ADDENDUM NO. 3
CONTRACT 17-01 WASTEWATER TREATMENT PLANT IMPROVEMENTS
SRF CW& 2019-432 & SRF 2019-433
FEDERAL EDA – 04-01-07217-01
DRA GRANT – TN-53991
FIDP – EDISON 59595
HUMBOLDT, TENNESSEE
WAUFORD PROJECT NO. 3626

Date of Addendum: Friday, March 8, 2019
Mandatory Pre-Bid Meeting Date: 10:00 AM Local Time, Thursday, March 7, 2019
Construction Bid Date: 2:00 PM Local Time, Thursday, March 21, 2019

SECTION B-23
 SCALE: 3/8" = 1'-0"

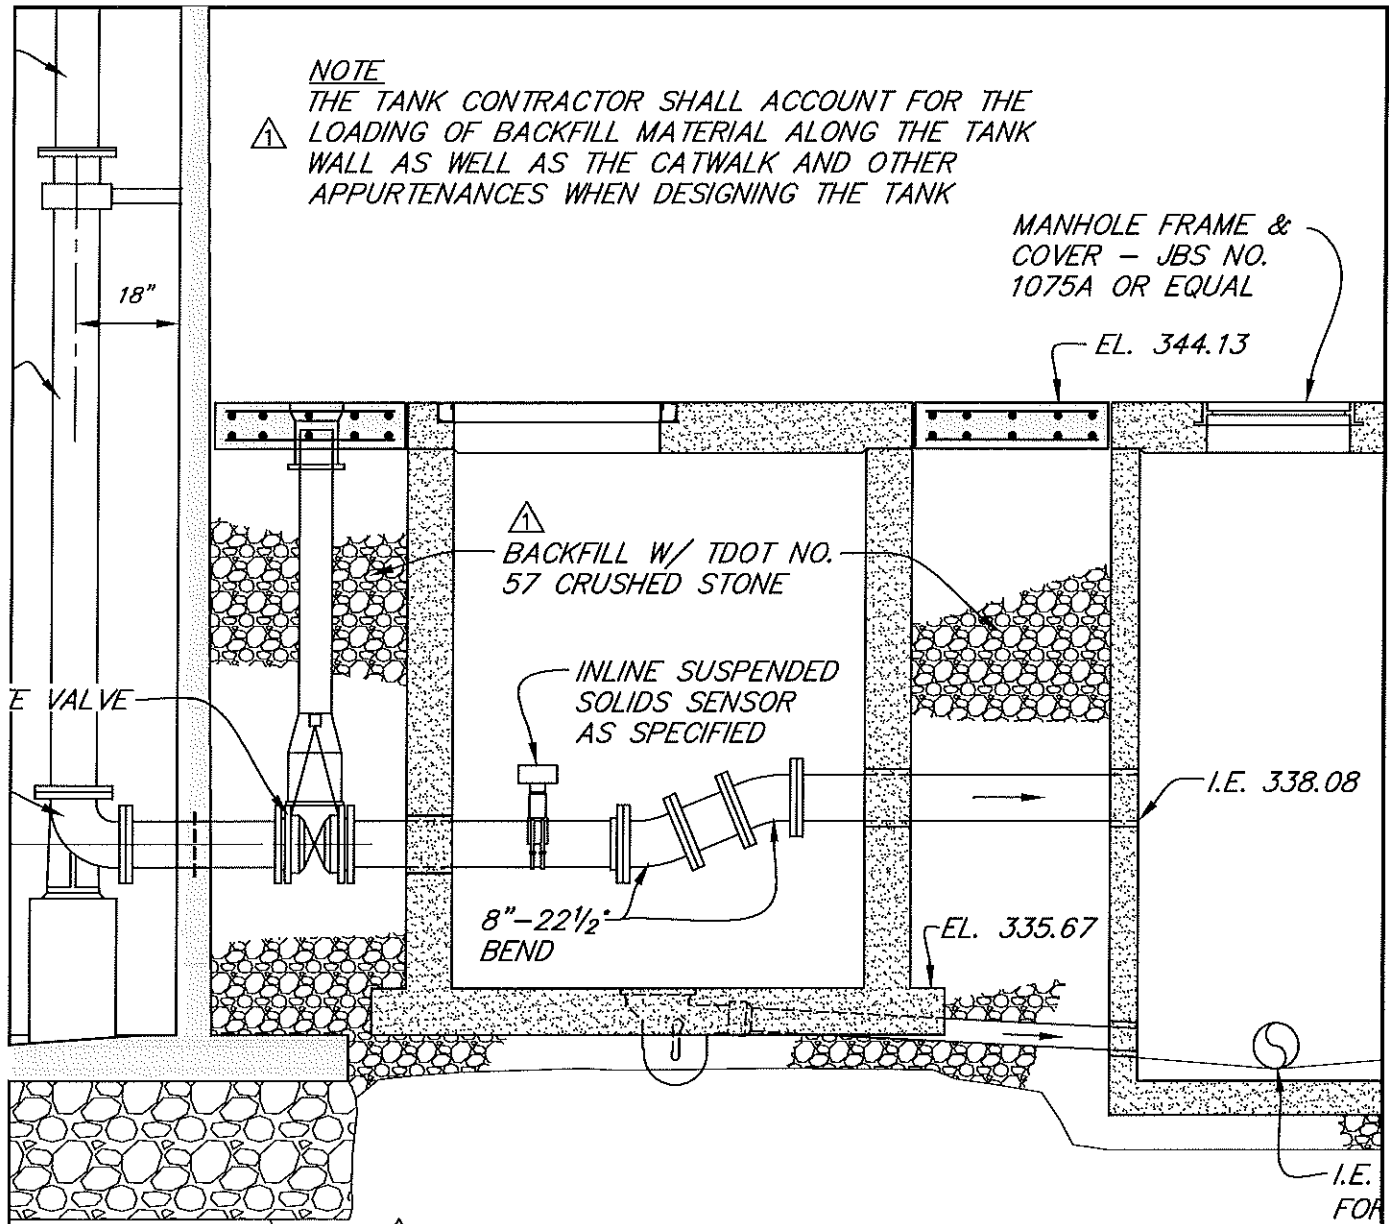
23. Plan Sheet 23, Digester Plans, Sections, and Details:

Replace “Section B-23” with the attached revised section.

NOTE
 THE TANK CONTRACTOR SHALL ACCOUNT FOR THE
 LOADING OF BACKFILL MATERIAL ALONG THE TANK
 WALL AS WELL AS THE CATWALK AND OTHER
 APPURTENANCES WHEN DESIGNING THE TANK

24" MIN. COMPACTED CRUSHED STONE

BIO-SOLIDS DEWATERING BUILDING
FLOOR PLAN

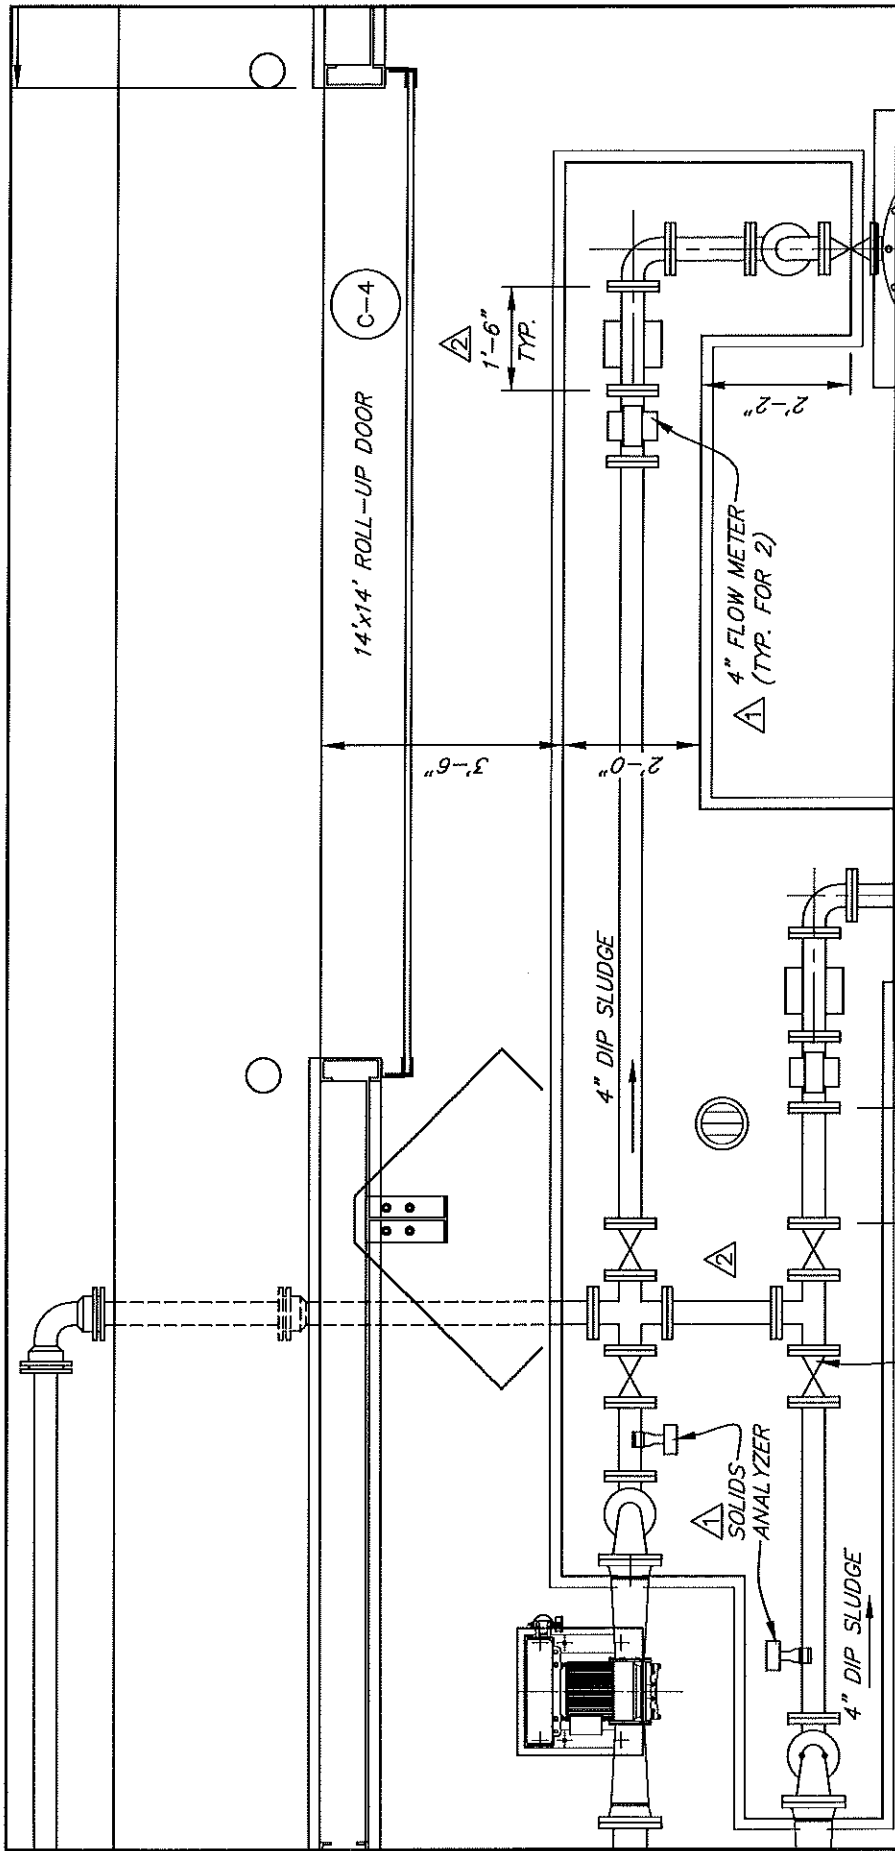
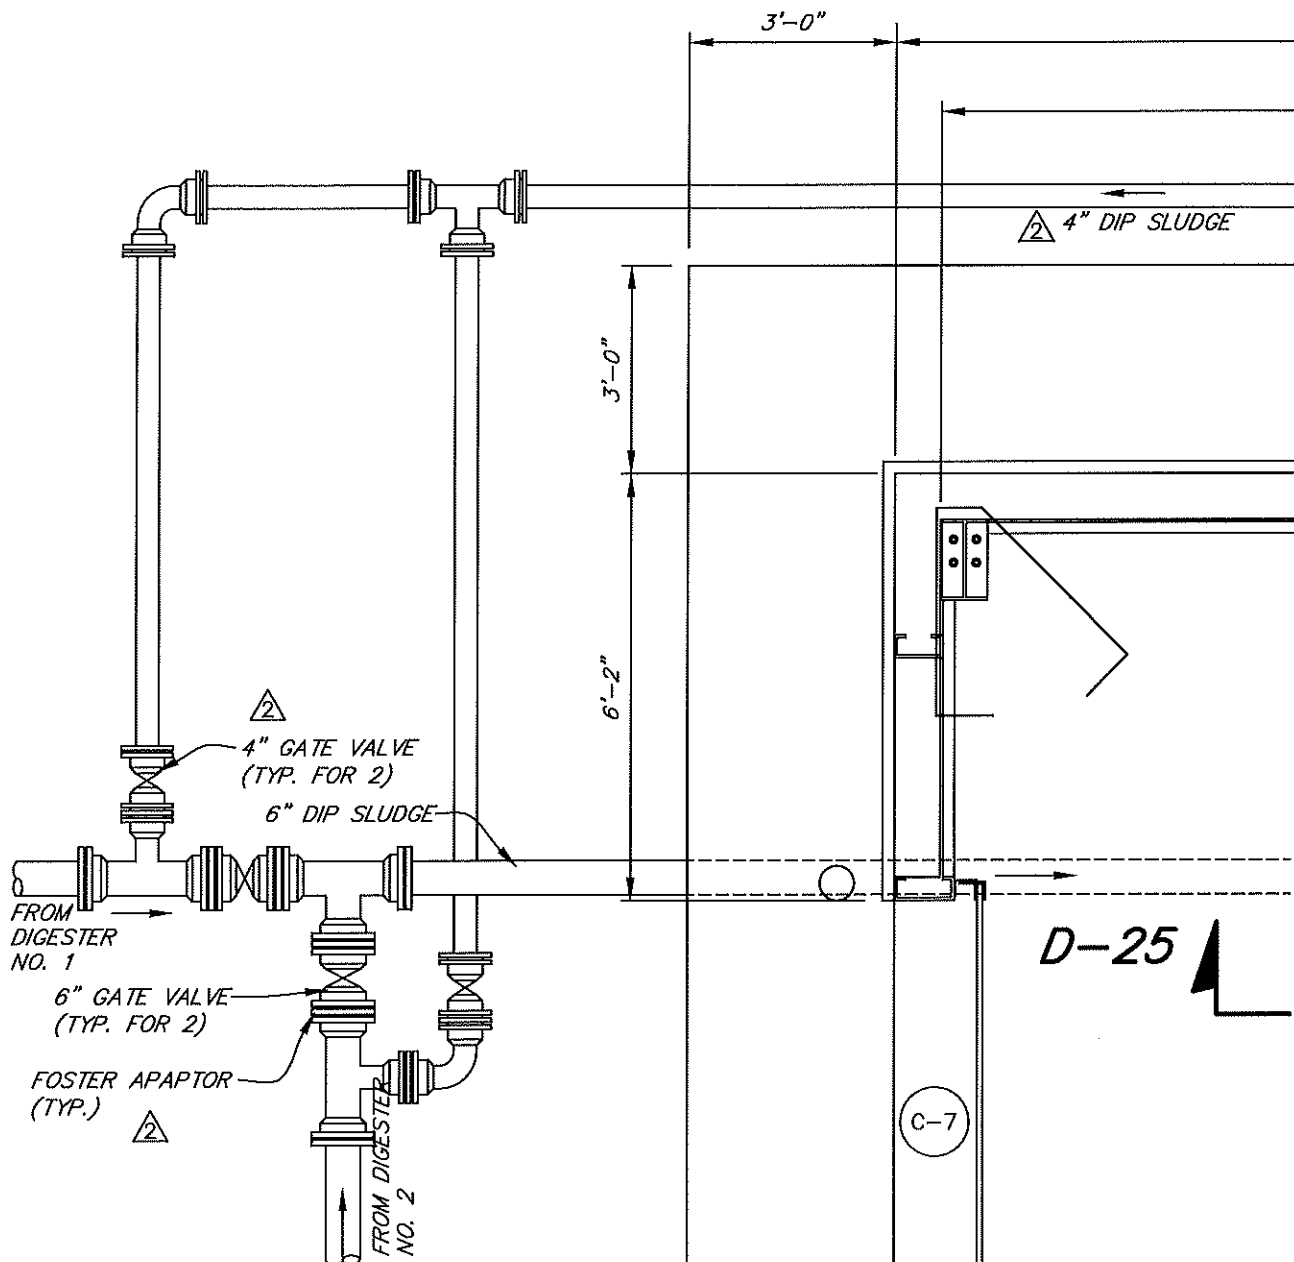
25. Plan Sheet 24, Biosolids Dewatering Building Floor Plan:

The sludge feed piping has been revised as shown on the attached partial biosolids dewatering building floor plan.
